SERVICE BULLETIN

ID No. SB-26-005
Ref. No. HP / TERN - 07292026
Release Date 8/12/26

CHARGE DOOR RELEASE CABLE – SB-26-005

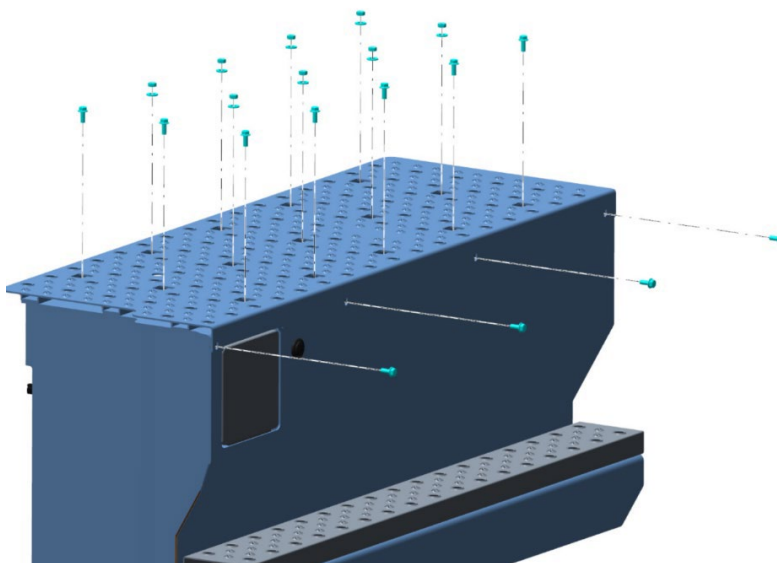
1. From behind the charge door (reaching up from below the step), release the cable from the charge door by rotating the cable end lock, and sliding the cable sleeve out of the mounting bracket.

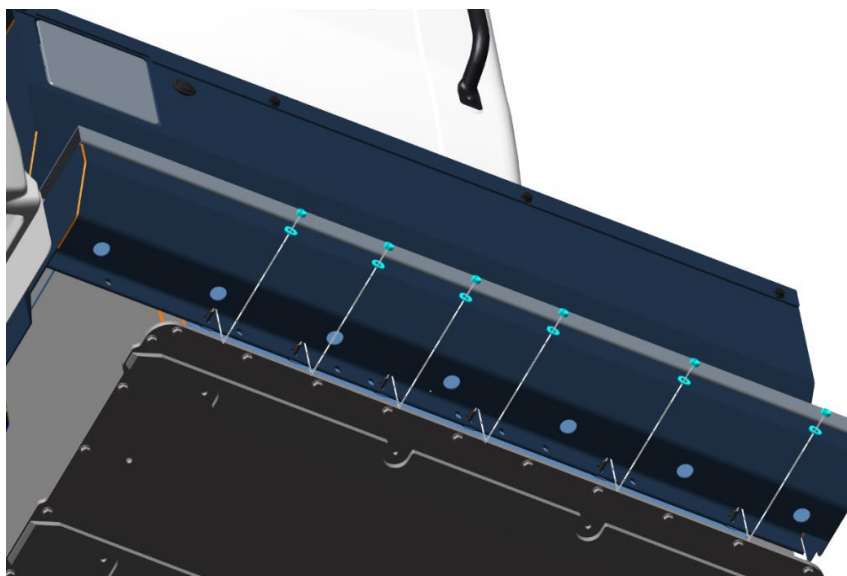
2. Remove 11 bolts and 8 nuts from the top and side of the step, and remove the driver's side upper step pad. (13.5 ft-lbs on reassembly)

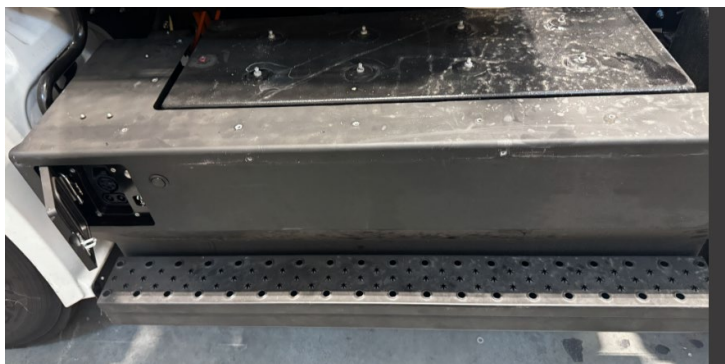
4. From the rear corner of the crash protection, access the cable by angling the crash protection outward and disconnect the cable from the charge door release button.
